SAFETY RECALL BULLETIN

Subject: **Safety Recall 09C5**
EPA07 DD13 Grid Heater

Safety Recall Bulletin 09C5

Figure 1 – Confirm Software Levels

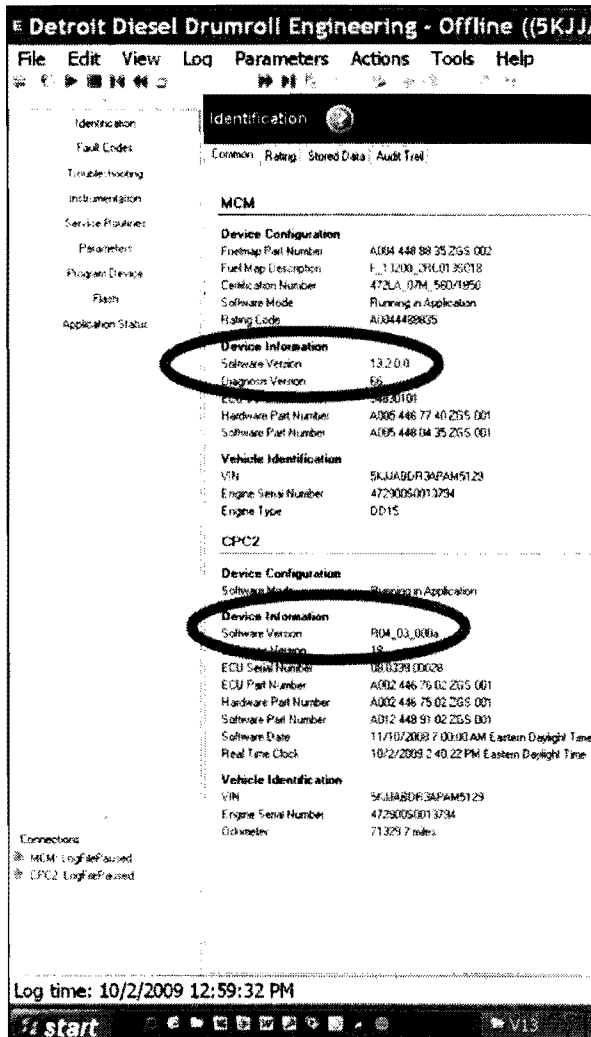
- b) Turn the vehicle ignition ON and wait one minute for the MCM and CPC to synchronize with each other.
 - c) Reconnect the USB Link, reconnect DDRS 7.04 to the MCM and CPC, and confirm the proper software levels. See Figure 1.

Figure 2 – Negative (Ground) Cable Connection At Grid Heater

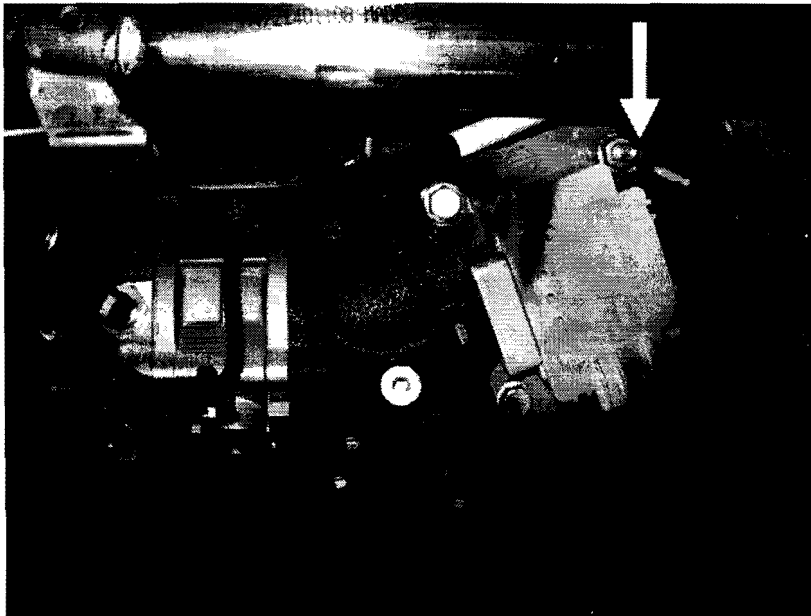
6. Turn the vehicle ignition OFF and disconnect the batteries.
7. Disconnect the negative (ground) cable from the grid heater and the vehicle frame and completely remove the cable from the vehicle. See Figure 2.

Figure 3 – Positive Cable Connection At Grid Heater

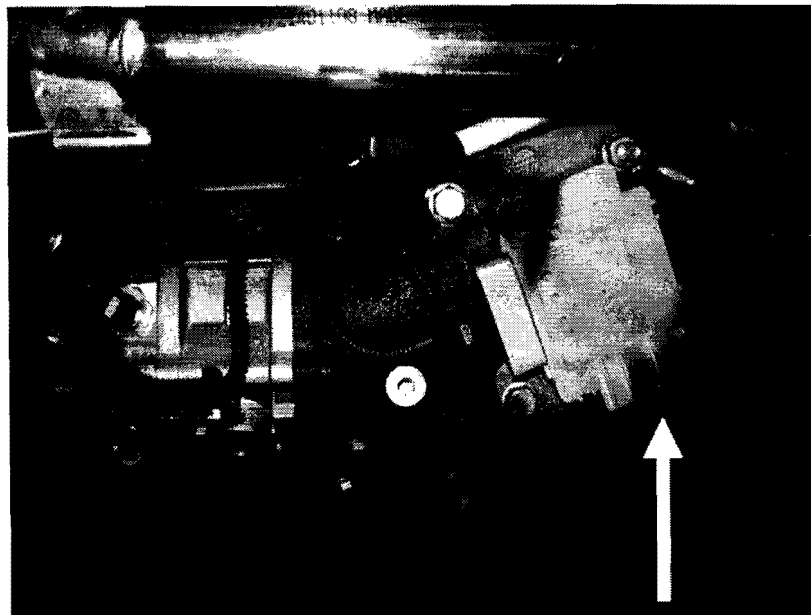
8. Disconnect the positive cable from the grid heater. See Figure 3.
